Subject: Request for Modification to the Section 404 Individual Permit and Section 401 Water Quality Certification for the proposed Greensboro Western Loop from north of SR 2176 (Bryan Boulevard) to SR 2303 (Lawndale Drive), Guilford County, Division 7. Federal Aid Project No. STP-NHF-124(1), WBS Element No. 34820.3.30, TIP No. U-2524C and D.

Since construction of the culvert at U-2524D, Permit Site 4, the portion of stream SV upstream of the culvert has experienced channel instability and erosion issues. In order to armor against further bank erosion, the Department is proposing to install an additional 70 linear feet of bank stabilization with Class I riprap and install a series of grade controls (rock steps) in this area.

Please see the enclosed revised permit sheets 11, 12 and 25 (of 25) as well as the new permit sheet 12a detailing the grade controls. No additional mitigation is required for the modified impacts (confirmed with USACE and NCDWR in December 2018).

PERMIT DRAWINGS  
SHEET 12 OF 25

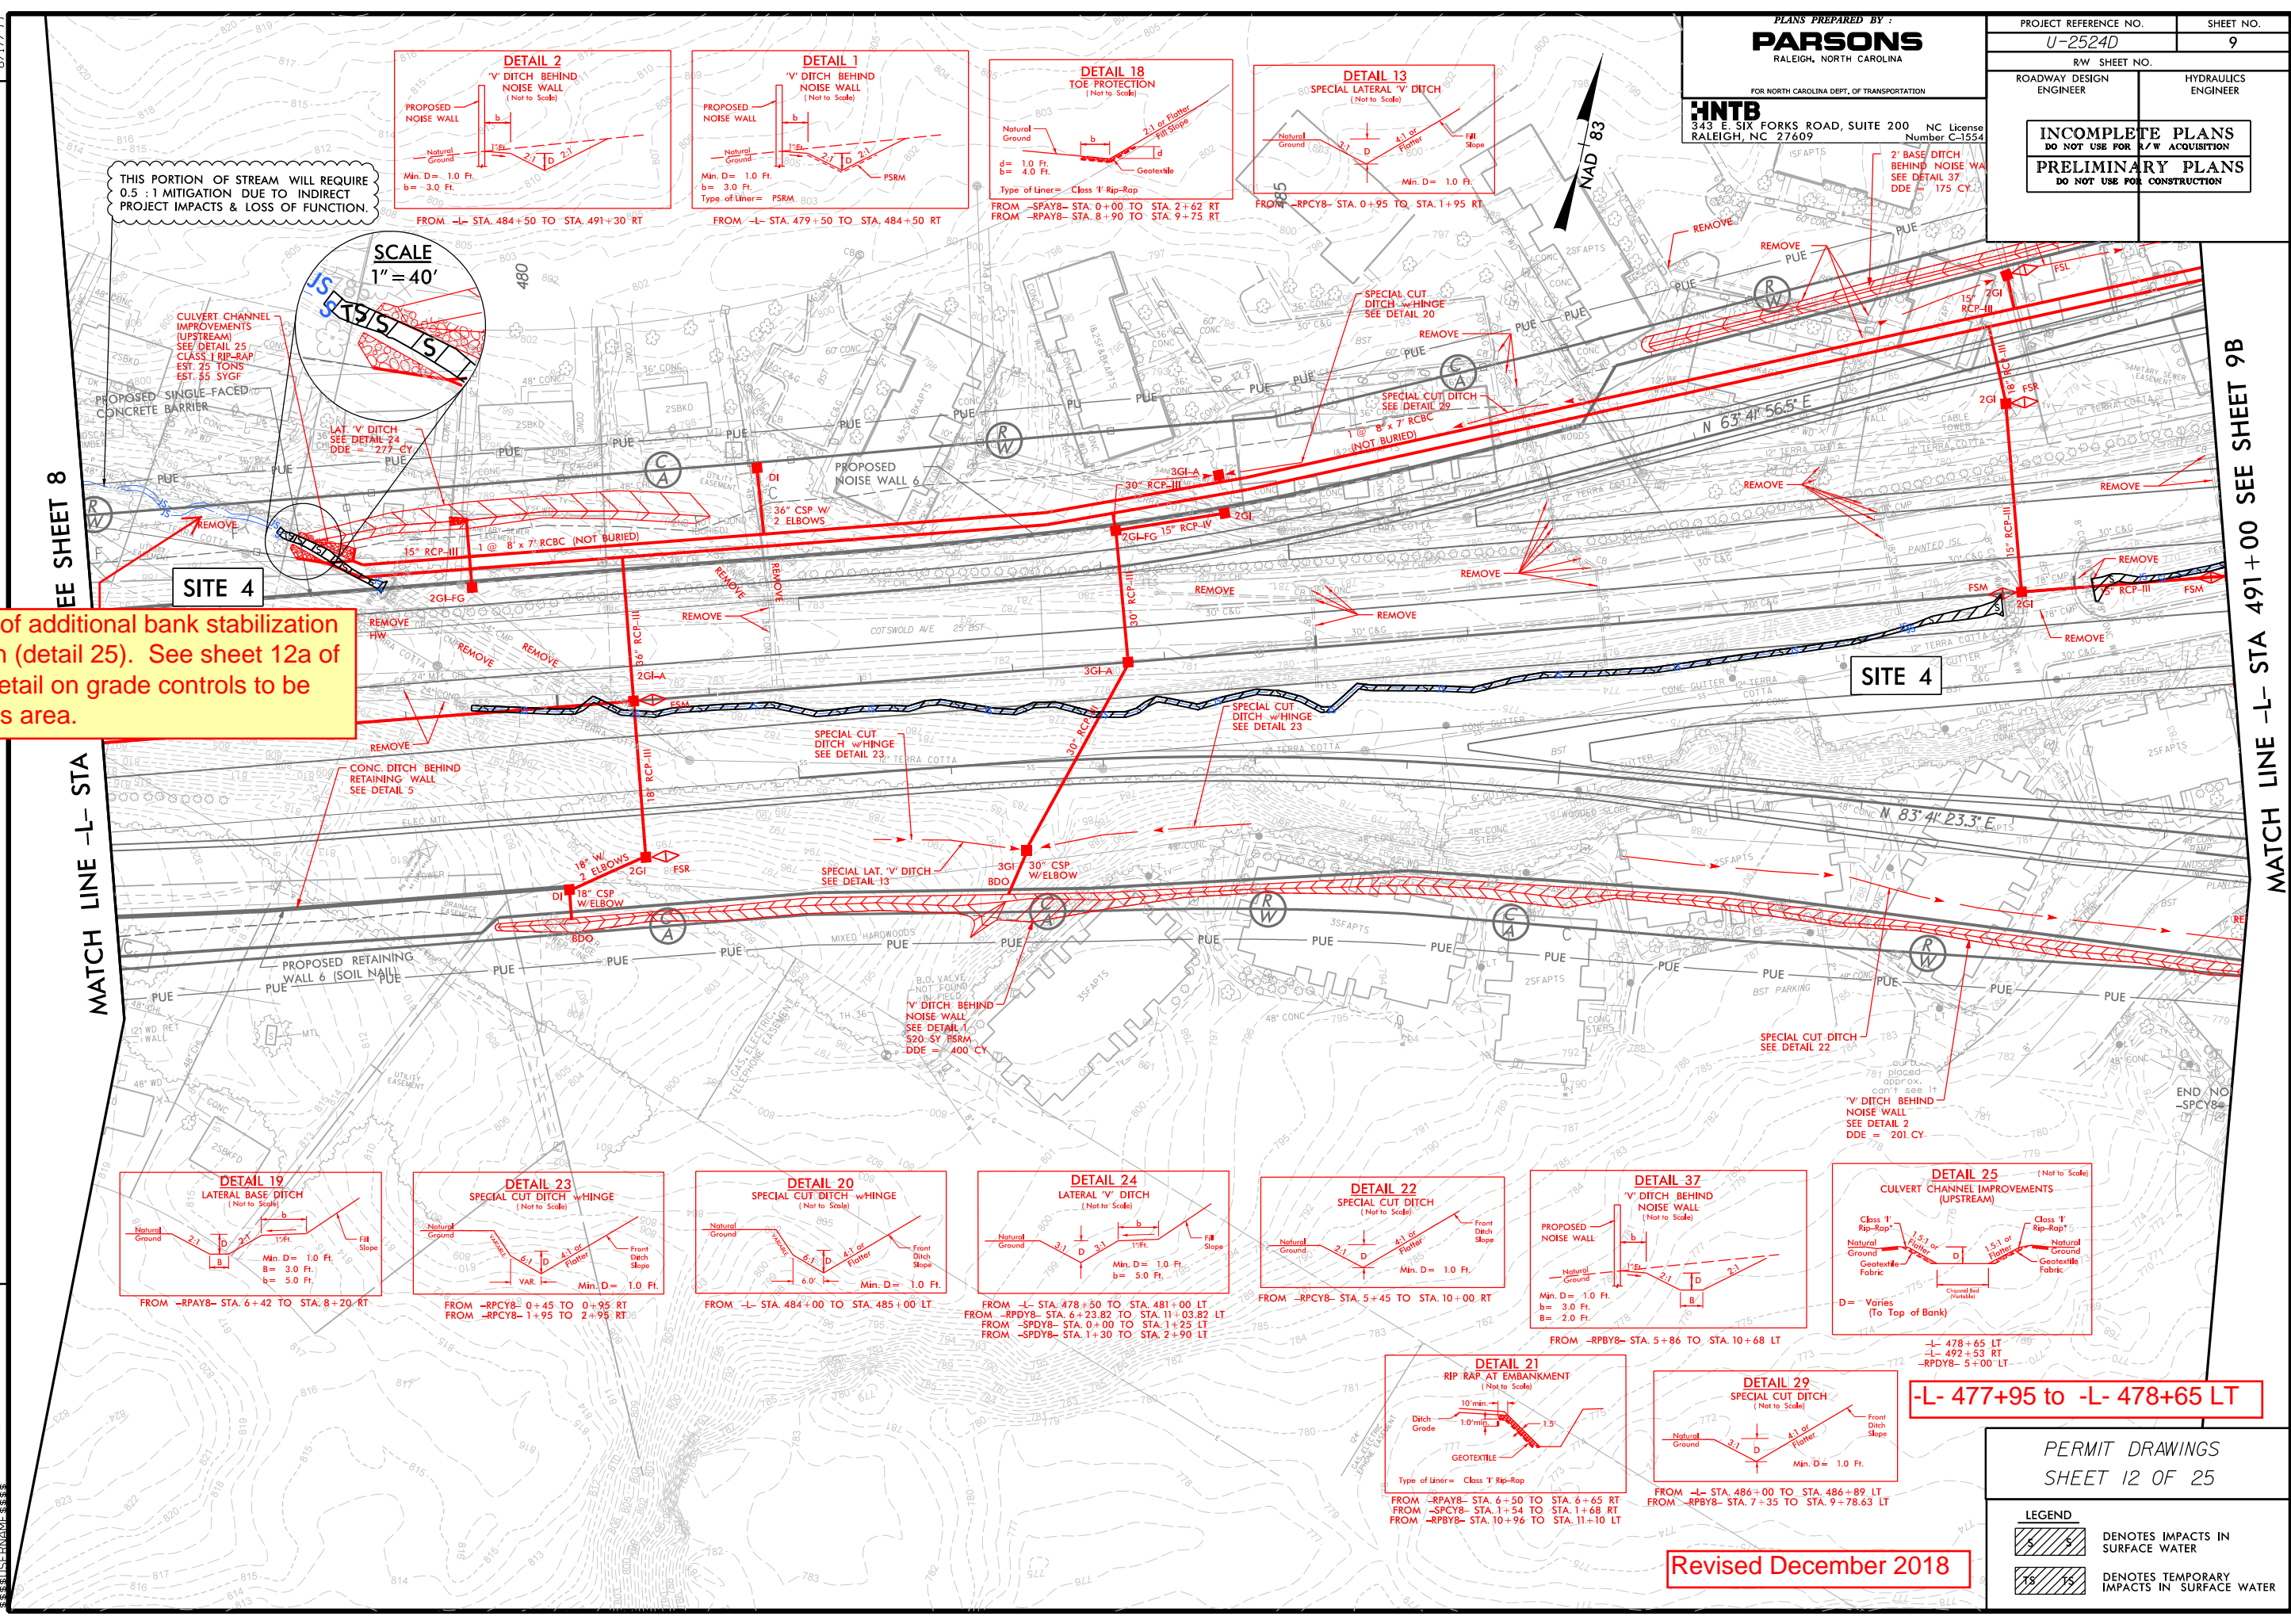
70 linear feet of additional bank stabilization in this location (detail 25). See sheet 12a of 25 for more detail on grade controls to be installed in this area.

-L- 477+95 to -L- 478+65 LT

Sheet 12a of 25  
December 2018

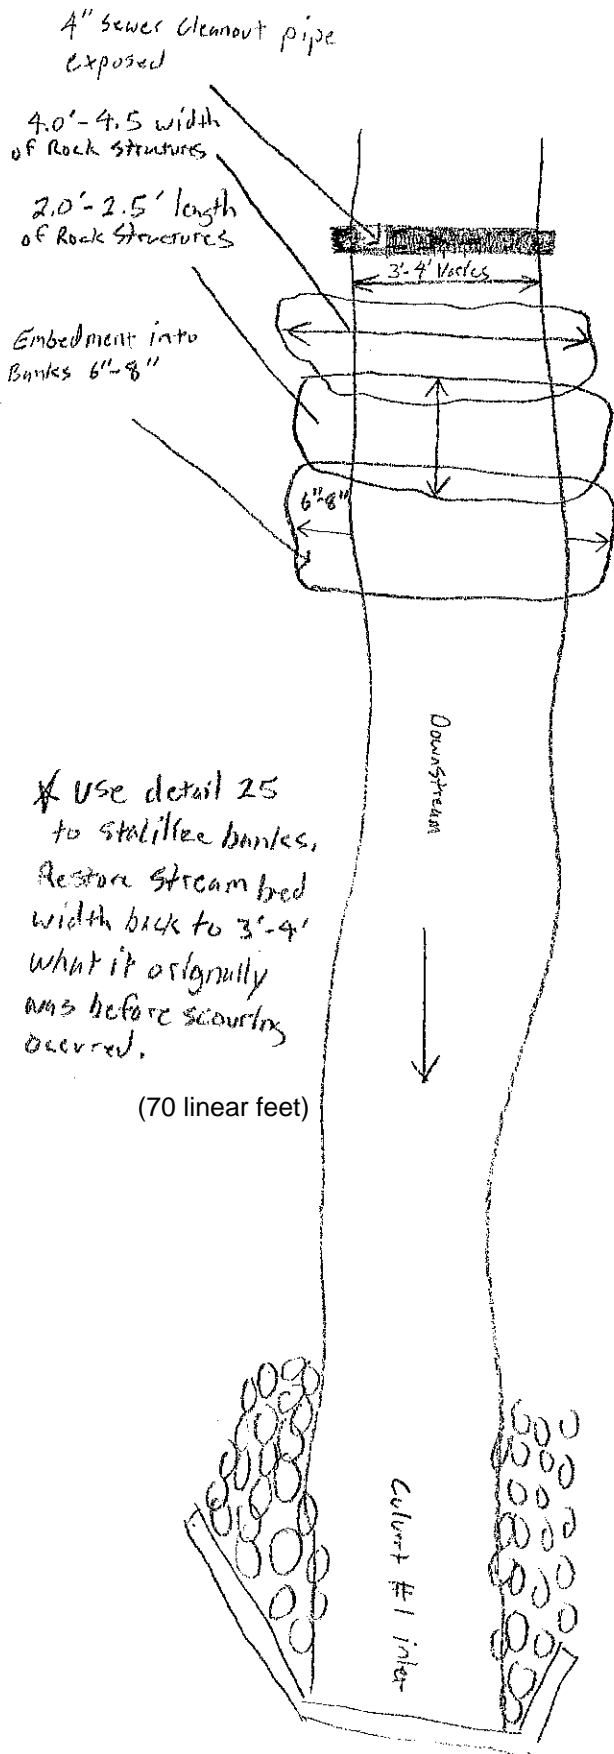
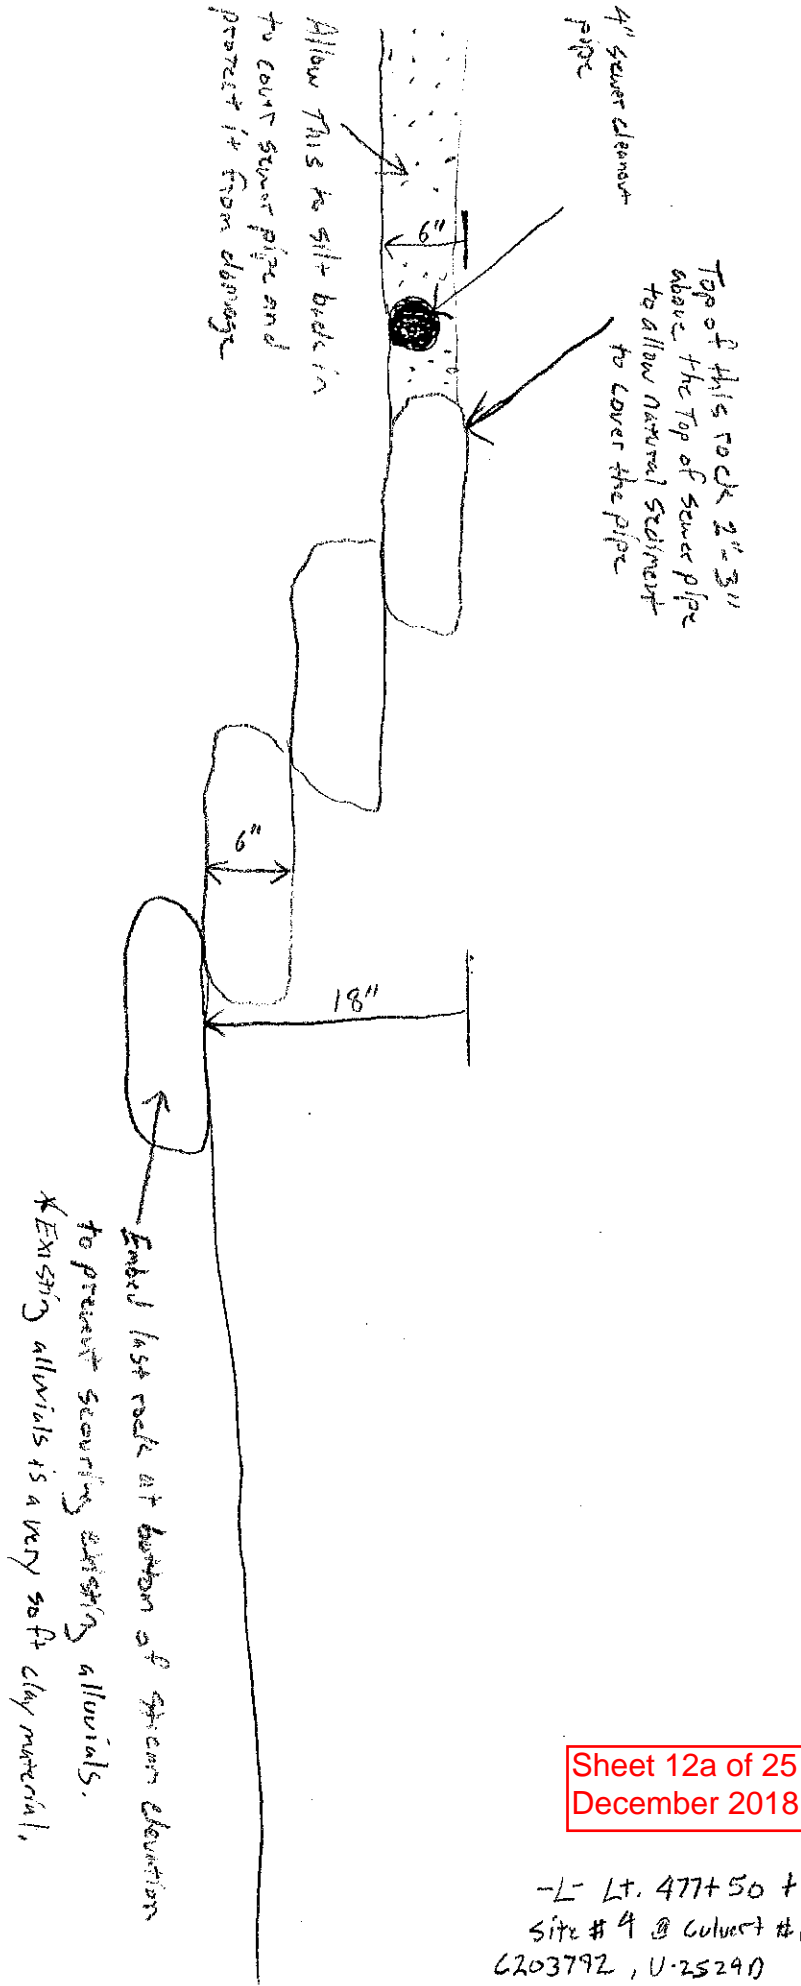
\* Use detail 25 to stabilize banks. Restore stream bed width back to 3'-4' what it originally was before scouring occurred.

Allow this to silt back in to cover sewer pipe and protect it from damage

Top of this rock 2'-3'' above the top of sewer pipe to allow natural sediment to cover the pipe

Embed last rock at bottom of stream elevation to prevent scouring existing alluvials. Existing alluvials is a very soft clay material.
